Access Compliance Report

Public Rights-of-Way

Intersection ID: 12671	Main Street: SEIGLE_AV	Cross Street: GREENWAY_CRESCENT_LN	Location: W
ADA ID: 4CA0A46E8BCD	Ramp Type: Directional1	Initial Pass/Fail: Fail	Overall Compliance: No
		Severity Score: 25

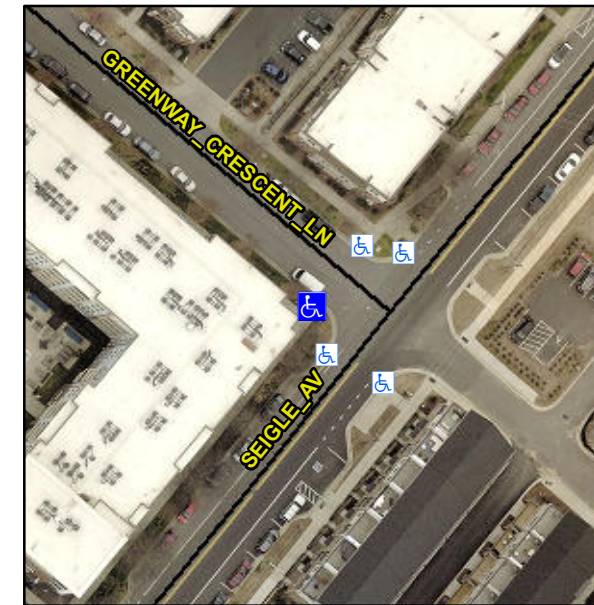
R304.2.2, R304.5.3

Compliance	Description	Data	Compliance	Description	Data
N/A	Ramp Length (in)	54.5	N/A	Grade Break?	N/A
Yes	Ramp Width (in)	68.0	N/A	Grade Break Slope (%)	0.0
No	Ramp Slope (%)	10.3	N/A	Grade Break XSlope (%)	0.0
No	Ramp XSlope (%)	5.5			
N/A	Flare Type LT	N/A	N/A	Flare Type RT	N/A
N/A	Flare Slope LT (%)	N/A	N/A	Flare Slope RT (%)	0.0
N/A	Flare Traversable LT?	N/A	N/A	Flare Traversable RT?	N/A
N/A	Landing Length (in)	0.0	N/A	DWS Provided?	N/A
N/A	Landing Width (in)	0.0	N/A	DWS Contrast?	N/A
N/A	Landing Slope (%)	0.0	N/A	DWS Length (in)	N/A
N/A	Landing X Slope (%)	0.0	N/A	DWS Full Width?	N/A
N/A	Landing Curb? (Y/N)	N/A	N/A	DWS Offset LT (in)	N/A
N/A	Shared Landing?	N/A	N/A	DWS Offset RT (in)	N/A
N/A	Gutter Ponding?	0.0	N/A	Gutter Slope (%)	N/A
N/A	Gutter Lip Ht (in)	0.0	N/A	Gutter X Slope (%)	N/A
N/A	Painted X Walk1?	No		Road Slope (%)	0.8
	X Walk 1 Direction	To NE		Road X Slope (%)	5.7
	X Walk 1 Width (in)	N/A		Clear Space?	N/A

X Walk 1 Slope (%)	0.8	N/A	Clear Space to XWalk (in)	N/A
	X Walk 1 X Slope (%)	5.7	N/A	Storm Grate/Utility Hazard?	N/A
N/A	Ramp inside XWalk1?	N/A		Storm Grate/Utility Type	
N/A	Any Obstructions?	N/A			N/A
	Obstruction Type		Yes	Surface Condition? (G/P)	Good
			N/A	Curb Slope (%)	13.6

Remove & Replace Entire Ramp.
